# Verified Carbon Standard

## NORTH PIKOUNDA REDD+ PROJECT

<b>Report ID</b>	VCS.22.VER.048
<b>Project title</b>	North Pikounda REDD+ project
<b>Project ID</b>	1052
<b>Verification period</b>	01/01/2013 to 31/12/2019
<b>Original date of issue</b>	10/02/2024
<b>Most recent date of issue</b>	05/12/2024
<b>Version</b>	02.2
<b>VCS Standard Version</b>	4.5
<b>Client</b>	Olam Agri
<b>Prepared by</b>	KBS Certification Services Ltd.
<b>Approved by</b>	Mr.Kaushal Goyal, Managing Director
<b>Work carried out by</b>	Team Leader and sector expert 14.1: Dr. D. Siddaramu Local expert - Rinah Zo Rakotonarivo Technical Reviewer – Mr. Praveen N Urs Expert for TR (14.1) – Mr. Shankar Shan Patro

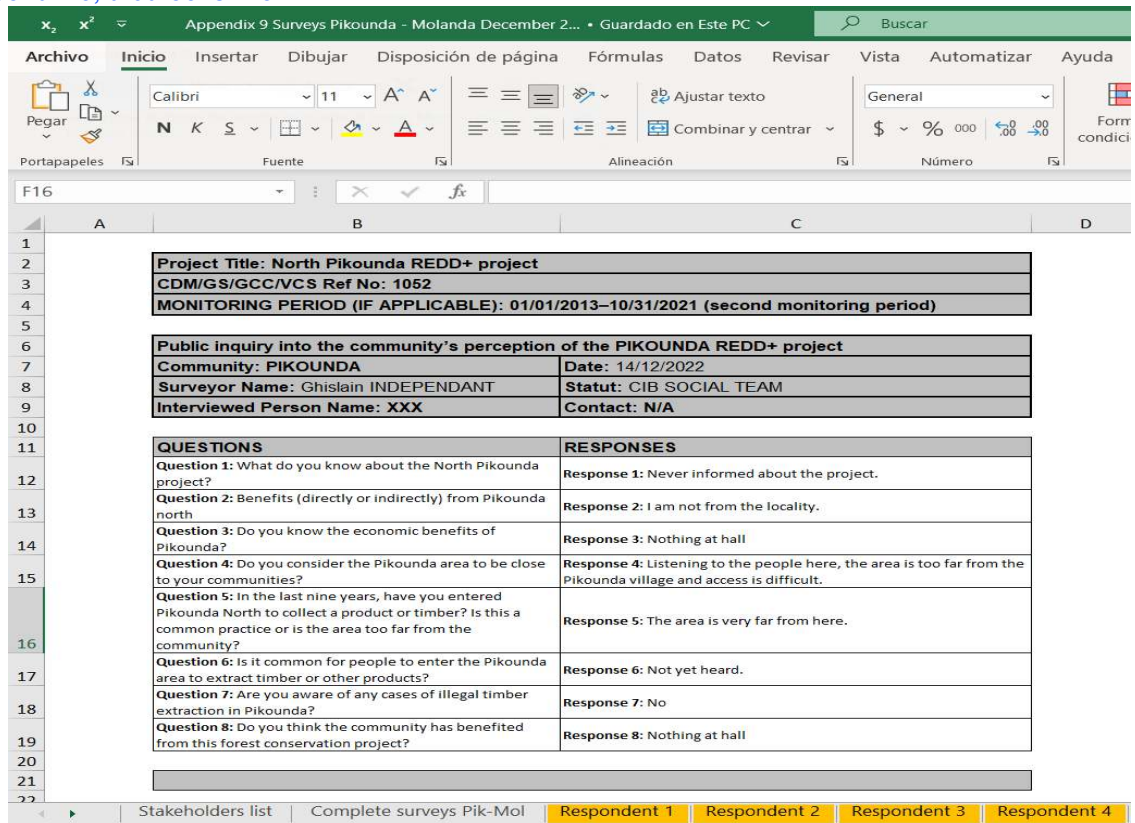
1. There is no Appendix 9 in the MR
2. Questionnaires not shared

The Questionnaires are submitted and clarification by PP is accepted. Hence CL04 is closed.
